Project	IEEE 802.16 Broadband Wireless Access Working Group < http://ieee802.org/16 >	
Title	A MAP IE for H-ARQ and SDMA Allocation in AAS Zone	
Date Submitted	2005-01-1826	
Source(s)	InSeok Hwang, Jaehee Cho, Seungj Maeng, JangHoon Yang, Hoon Huh, SangHoon Sung, Jaeho Jeon, Soonyoung Yoon Samsung Electronics, Inc.	is91.hwang@samsung.com
	Ran Yaniv, Tal Kaitz Alvarion Ltd.	ran.yaniv@alvarion.com
	Dave Pechner, Doug Dahlby, Todd Chauvin ArrayComm Inc.	dpechner@arraycomm.com
Re:	Call for reply comments (Original Comment # 2189)	
Abstract	A new efficient Normal MAP IE supporting for Hybrid ARQ and SDMA allocation in AAS zone is proposed.	
Purpose	Adoption in IEEE 802.16e_D6	
Notice	This document has been prepared to assist IEEE 802.16. It is offered as a basis for discussion and is not binding on the contributing individual(s) or organization(s). The material in this document is subject to change in form and content after further study. The contributor(s) reserve(s) the right to add, amend or withdraw material contained herein.

A MAP IE for H-ARQ and SDMA Allocation in AAS Zone

Fig. 1. Proposed SDMA Allocation Scenario

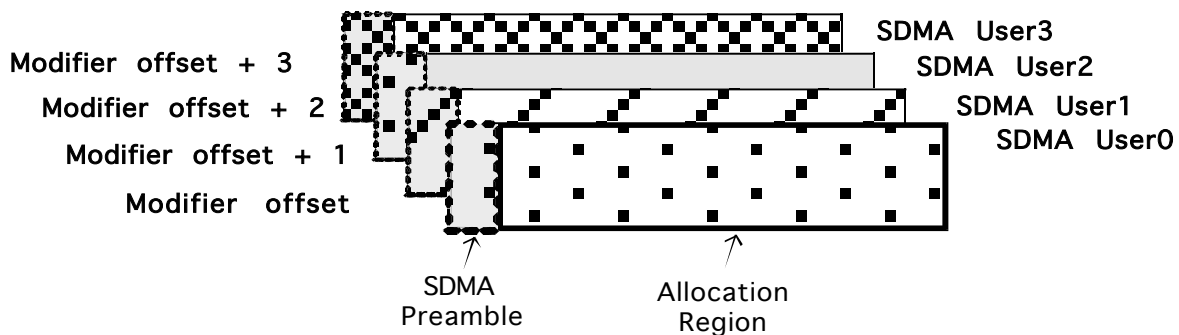
The burst allocation region of SDMA users can be fixed for scheduling simplicity and lower signaling overhead. In addition, modifier index for SDMA preamble can be extracted from description order of SDMA users. The proposed solution can be summarized as follows

- 1) Introduce Extended IUC in DL/UL MAP for SDMA allocation (not available yet)
- 2) Use '1' of '5' reserved bits in AAS_IE() to specify modifier type, "Time" or "Freq." shift
- 3) Describe the shared 2D (DL) or 1D (UL) allocation regions

Figure XXX – Pilot patterns for AAS mode in AMC zone. Symbol offset is relative to the beginning of the zone. Pilot polarity for each pattern is given in brackets.

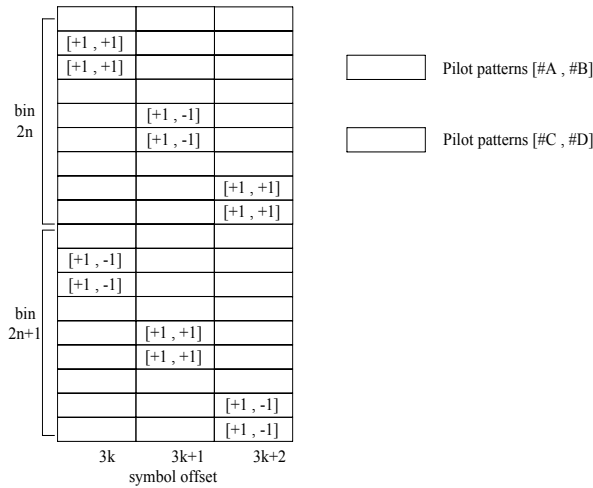
8.4.6.3.2 AMC support for SDMA

The pilots in an AMC AAS zone are regarded as part of the allocation, and as such shall be beamformed in a way that is consistent with the transmission of the allocation's data subcarriers. In an SDMA region, the pilots of each allocation may correspond to a different pilot pattern. A pilot pattern consists of location and polarity. The pilot patterns are depicted in figure XXX. Data subcarriers shall be punctured to obtain patterns #2 and #3. Subcarriers shall only be punctured if there is an allocation associated with the corresponding pattern, as described in the AAS SDMA DL IE() and AAS SDMA UL IE(). Only MSSs that support all four pilot patterns, as indicated by their capability in 11.8.3.7.X, shall be assigned allocations in an SDMA region where pilot patterns #2 and #3 are used. Data subcarriers shall be punctured after constellation mapping in the case of CC encoding, and prior to constellation mapping in the case of CTC encoding. In the latter case, the FEC block shall be truncated to accommodate the punctured subchannel structure, and the data subcarrier enumeration of Eq. (116) shall not be applied. Instead, data subcarriers within a slot shall be enumerated starting from the first OFDMA symbol at the data subcarrier that is lowest in frequency, continuing in ascending frequency order throughout the slot's subcarriers in the same symbol, then going to the next symbol at the subcarrier lowest in frequency, and so on.
